**DEFENSE NUCLEAR FACILITIES  
SAFETY BOARD**

February 2, 2015

**SUBJECT:** Seismic Control Strategy Deficiencies in the Safety Design Strategy for the High-Level Waste Facility

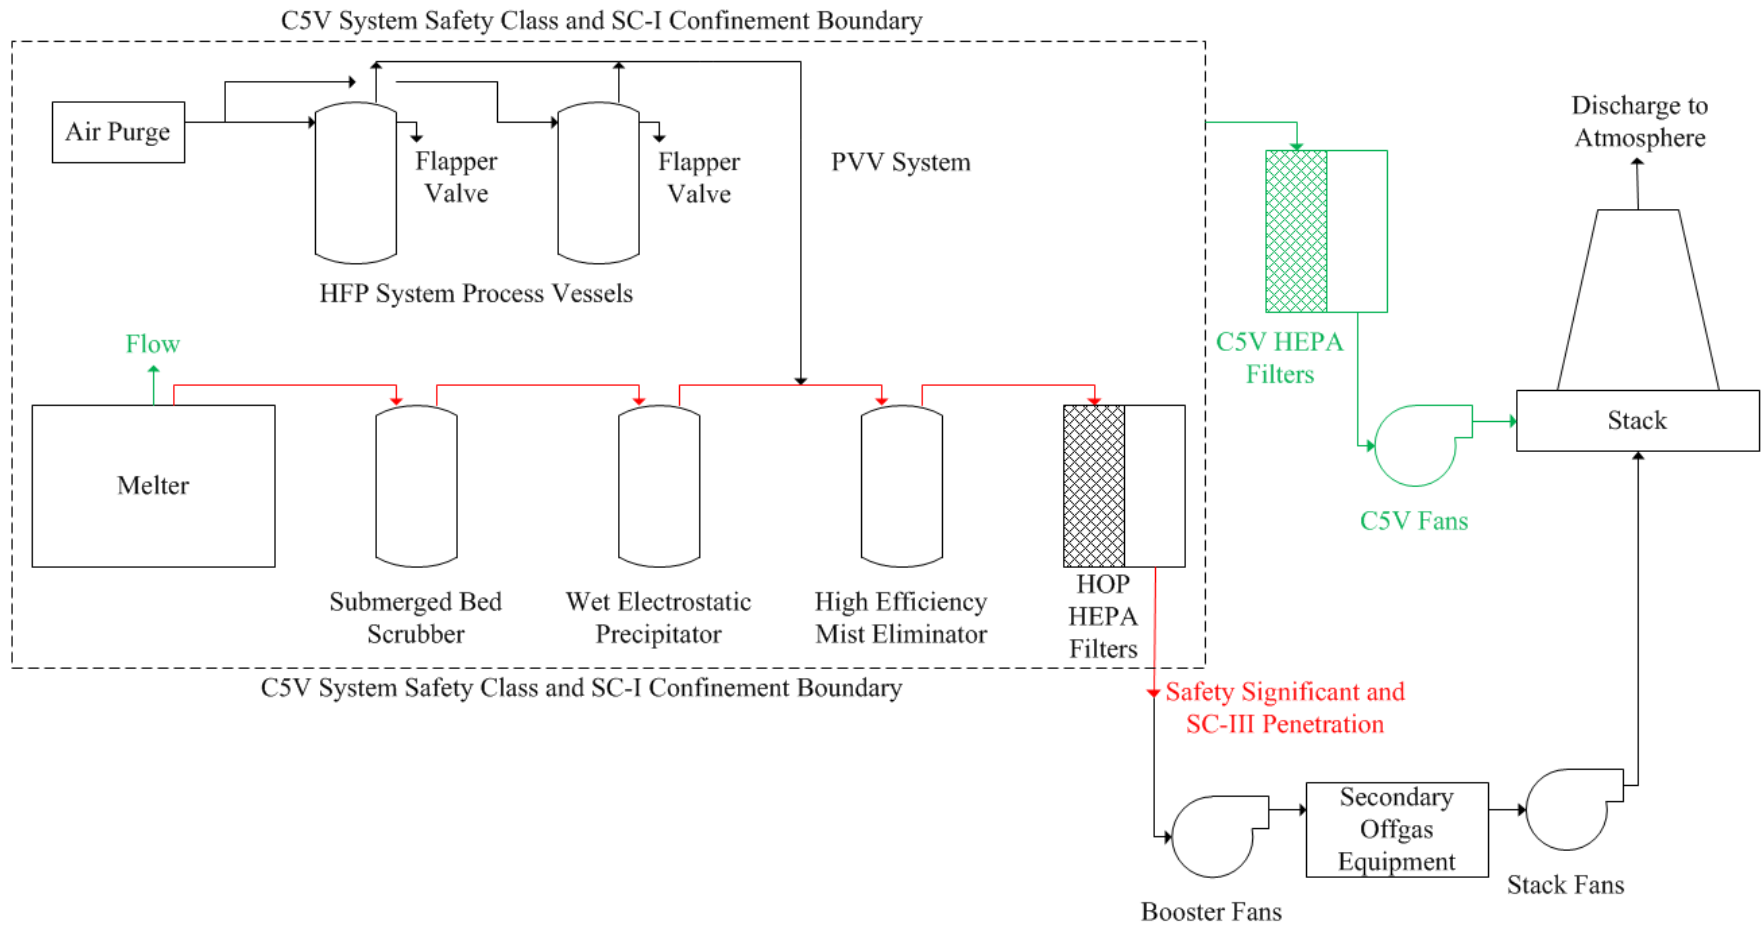
- The SDS proposes downgrading the submerged bed scrubber and the HOP system HEPA filters to safety significant and SC-III. As a result, a potential unfiltered release pathway for radioactive offgas exists to occupied spaces outside the confinement boundary of the C5V system and possibly to the environment. Figure 1 illustrates this potential flowpath.
- Following a seismic DBA, the HFP system vessels will be above atmospheric pressure. Because the SDS proposes downgrading the HOP system HEPA filters to safety significant and SC-III, a potential unfiltered release pathway exists to occupied spaces outside the confinement boundary of the C5V system and possibly to the environment. Figure 2 illustrates this potential flowpath.
